DRAINAGE REPORT
For
Sunrise Ranch Subdivision

**Re: Revised Drainage Plan for Sunrise Ranch
Engineer's stamp 6-23-00 (J22/D66)**

Re: Sunrise Ranch Drainage Report
Engineer's Stamp dated 5-3-00 (L9/D6)

RE: SUNRISE RANCH (ZAP L8)

TITLE:	SUNRISE RANCH SUBDIVISION GRADING AND DRAINAGE - PHASE 1	
DESIGN REVIEW COMMITTEE	CITY ENGINEER APPROVAL	MO./DAY/YR.
DESIGNED BY	DATE	3/00
DRAWN BY	DATE	3/00
CHECKED BY	DATE	3/00
CITY PROJECT NO.	ZONE MAP NO.	SHEET OF
	L-8, L-9	1 1

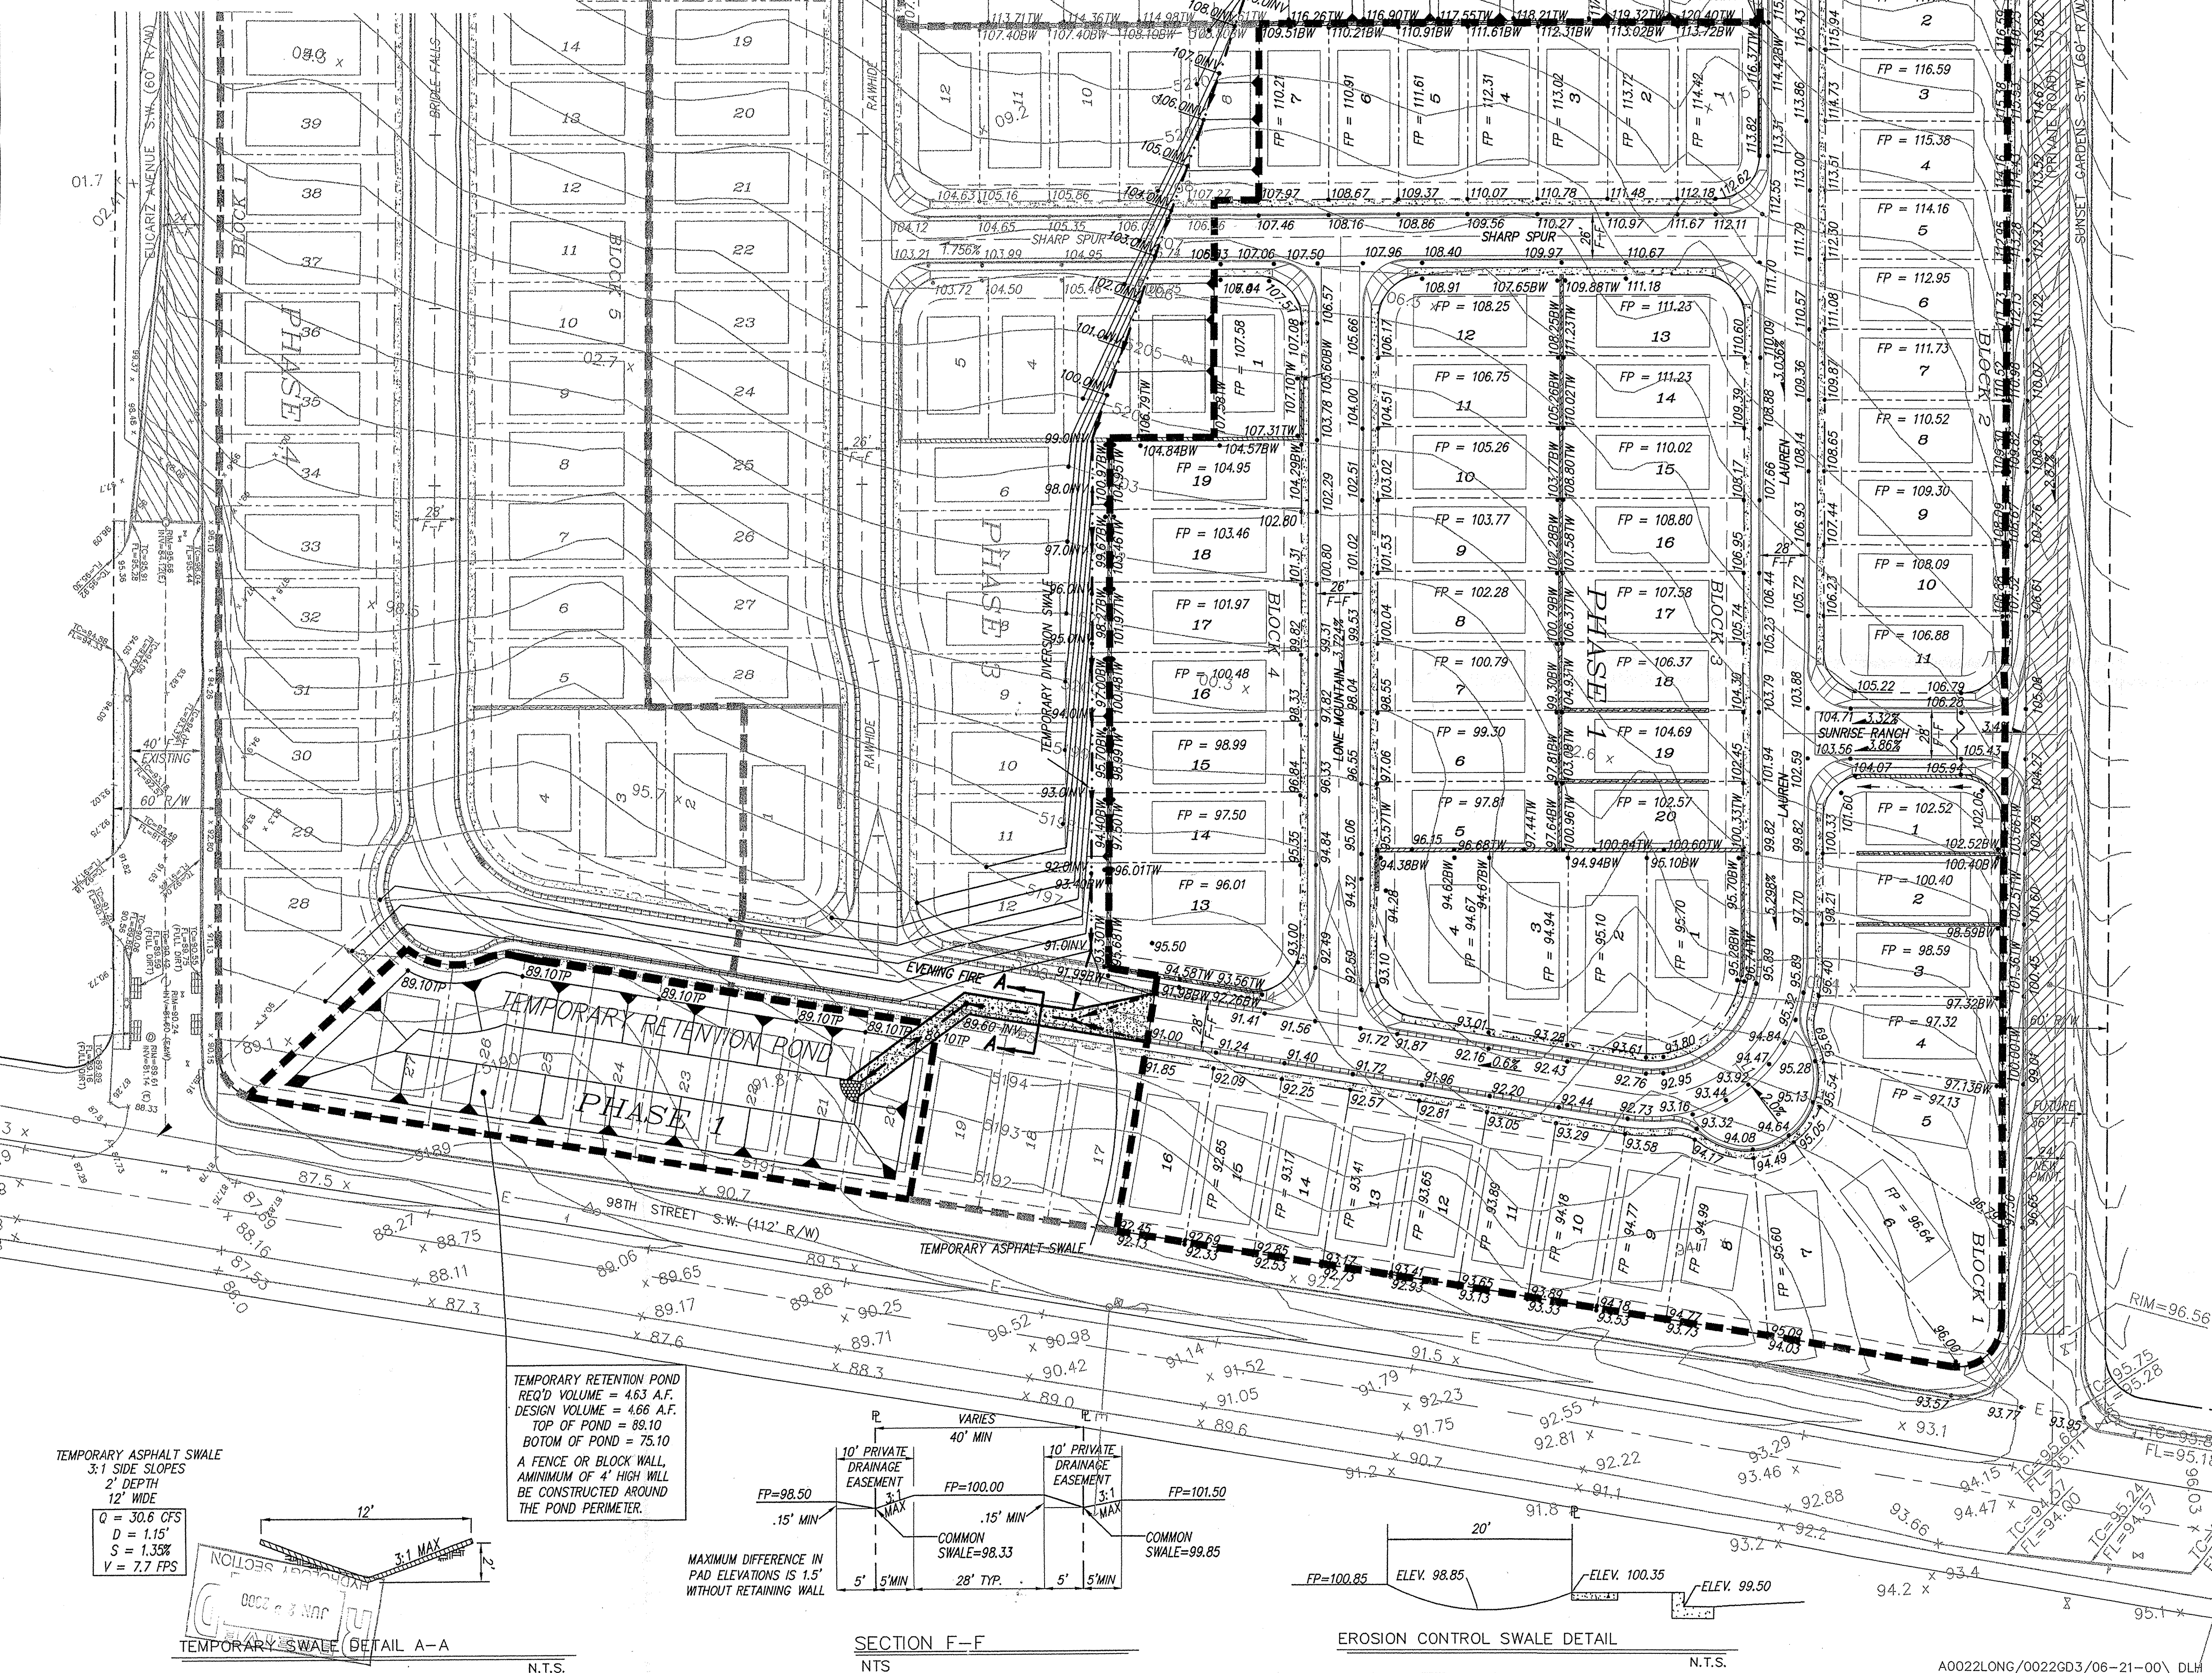
- Please provide a copy of the Preliminary Plat for comment.
- Please indicate on the grading plan the erosion setback and the limits of the floodplain. A drainage easement, dedicated to AMAFCA, should encompass the erosion setback area. Please provide a HEC analysis of the incoming arroyo and provide scour depths for the floodwall footing (as you know, the top of footing must be below scour depth).

- Please show retaining wall along the back of lots 5-17, Block 7. It also appears that a retaining wall will be needed south of lot 48, Block 7 (this may be lot 47 since there is a discrepancy with the phase plan); south side lot 13, Block 6; between lots 18-20, Block 3.
- Please remove the valley gutter from the knuckle @ Bridle Falls and Evening Fire.
- With respect to the temporary diversion swale, please show the contributing basin, pertinent spot elevations, typical section, runoff and add this runoff to your calculation for your asphalt rundown.
- Please use the FHWA nomograph for concrete culverts, not corrugated metal.
- Please modify Note 2 to include "...unless masonry walls are indicated."

1. A preliminary plat has been provided with this submittal.
2. The limits of the existing 100 year floodplain and the calculated 14.5 foot erosion setback have been added to the grading and drainage plan. An existing public drainage easement encompasses a majority of the floodplain limits as shown on the revised G&D plan. Since no development or grading is allowed or being proposed within the limits of the existing floodplain in Tract A it does not seem necessary to dedicate a drainage easement to AMAFCA at this time. When Tract A is proposed to be subdivided for development the limits of the drainage easement can be clearly defined and dedicated to AMAFCA.

6. Retaining walls have been added to Lot 48, Blk 7 and Lot 13, Blk 6 and between Lots 18-20, Blk 3 as requested. Retaining walls are not necessary on lots 5-17, Block 7.

9. The FHWA nomograph for concrete culverts has been used.
10. Note 2 on the grading and drainage plan has been revised accordingly.
